# 4RUNNER

## OUTLINE OF NEW FEATURES

The following changes are made for the 2008 model year.

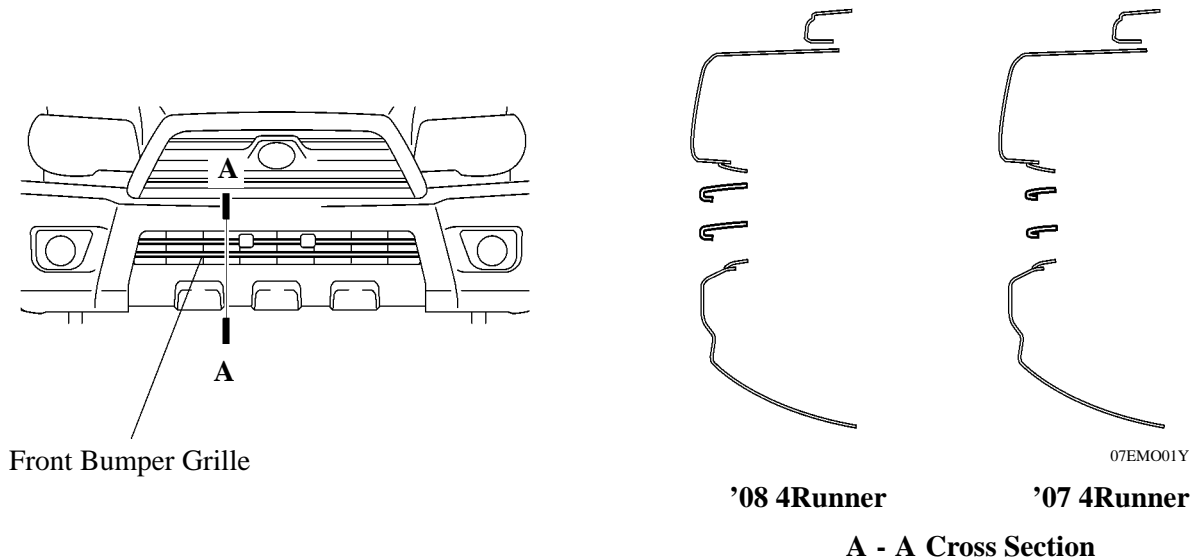
The design of the front bumper grille has been changed.
